SEWAGE DISPOSAL SYSTEM

DEPARTMENT OF HEALTH AND MENTAL HYGIENE

HOWARD COUNTY HEALTH DEPARTMENT

REPAIR - PURPOSE - INCREASE THE SIZE OF THE SEPTIC SYSTEM TO HANDLE THE INCREASE IN WASTEWATER FLOW FROM THE PROPOSED ADDITION (increase in the number of bedrooms from 3 to 6 bedrooms) IN SUPPORT OF BUILDING PERMIT APPLICATION No. B00102547.

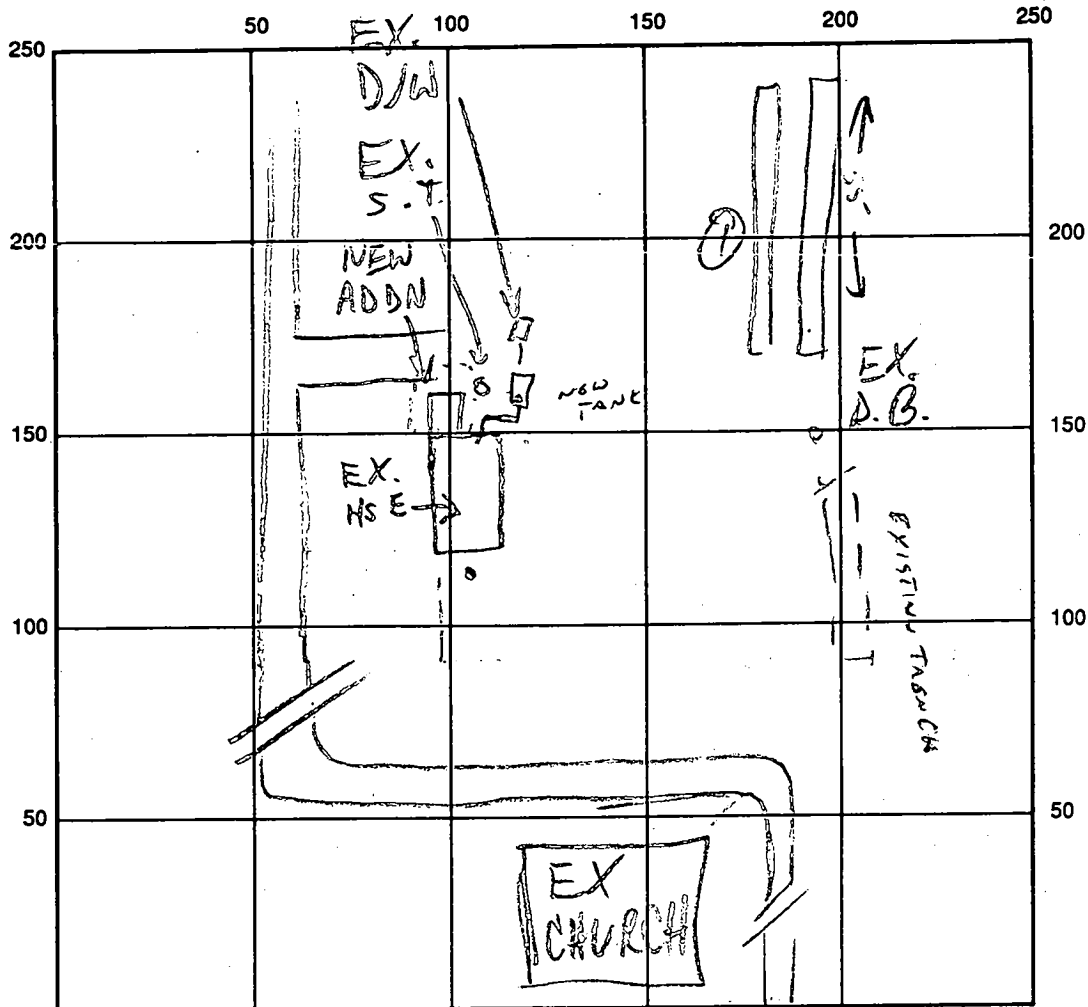
INV 3 1/2' B&T 2 1/2'; (2) 55' TRENCHES OK FOR 6" ± GRADE DIFF);

S.T. LOC. VERY TIGHT FIT TO GET 10' OFF ADD'N & EX HOUSE; OK FOR ALL NEC. BENDS TO FIT. NEED C/D BEFORE NEW S.T. @ FIRST BEND OUT OF HOUSE

REMARKS: 2 - 90° BENDS BETWEEN HOUSE AND TANK, ACCEPTED AS ONLY PRACTICAL MEANS TO FIT TANK INTO EXISTING AREA.

2 - 155° TRENCHES ADDED.

EXISTING SEPTIC TANK TO BE PUMPED OUT & COLLAPSED,

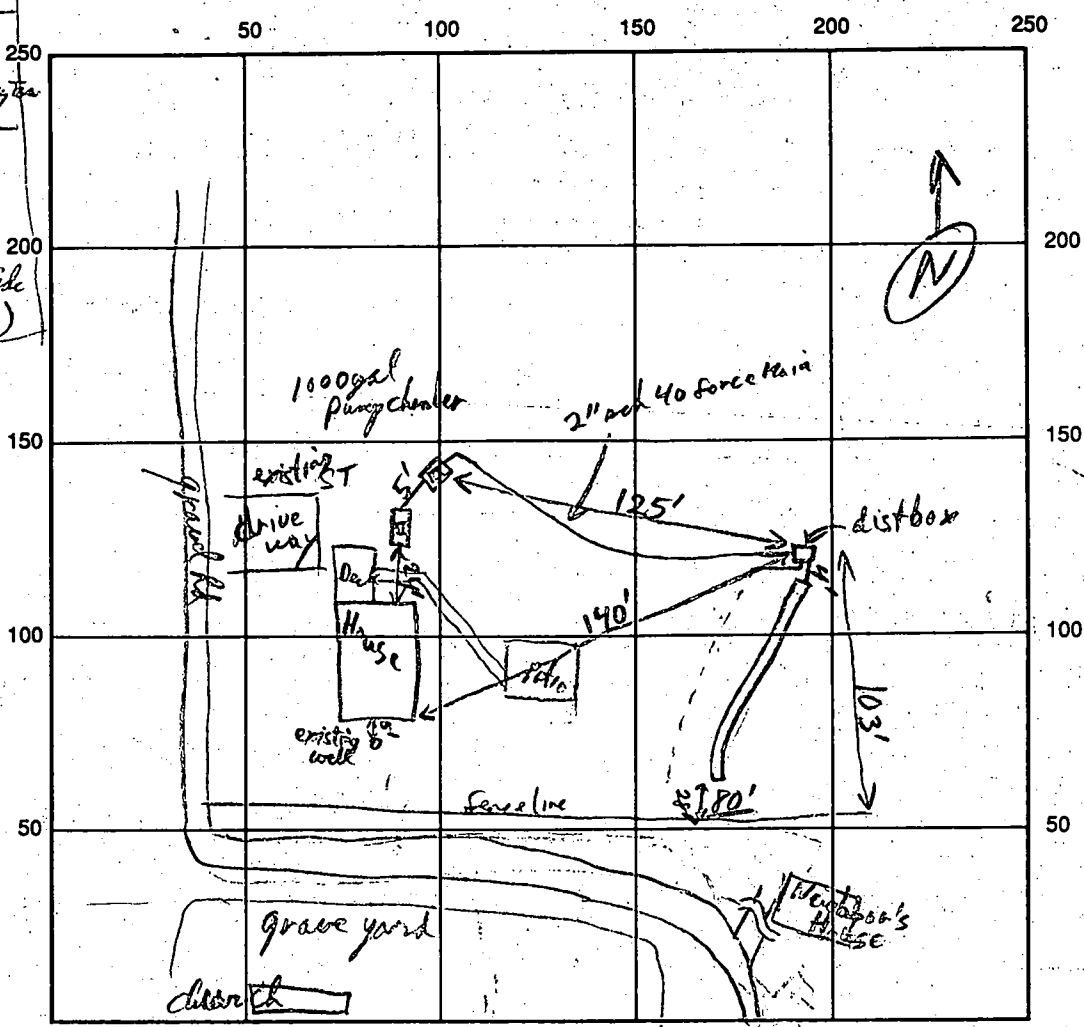
180 sq ft/bdrm. Inlet at 4.0 ft, Bottom at 7.5 ft, 160 linear ft of trench. Stay 100 ft off wells. Pump pit (top seam recommended) dual effluent pumps w/ alarms. 6-26-92 JEN

Plans Approved By: Note for Septic Tank has no baffles to eff - OK to use conventional septic tank - If use 1000 gal / 4 1/2' x 8' x 28" deep pump chamber (giving 1 day's storage capacity above high water alarm, you may use single effluent pump rather than dual pumps)

SEPTIC TANK LEVEL Existing 750 gal? (4280) ^{concept} OK - Failure due to never pumping ST.
 CLEANOUTS Min holes created of SOT. + PL. (1 ft cover) only
 pump chamber 1000 gal - OK
 DISTRIBUTION BOX LEVEL OK

REMARKS: Pump Chamber placement OK, Force Main OK, 1st Trench Excavation OK - Call Tomorrow
for second trench - OK to begin gravel filling 1st Trench RPP 8/16/92 1st Trench OK to cover
Second Trench OK to place gravel RPP 8/16/92 OK to cover Trench - Still need pump test.
RPP 8/17/92
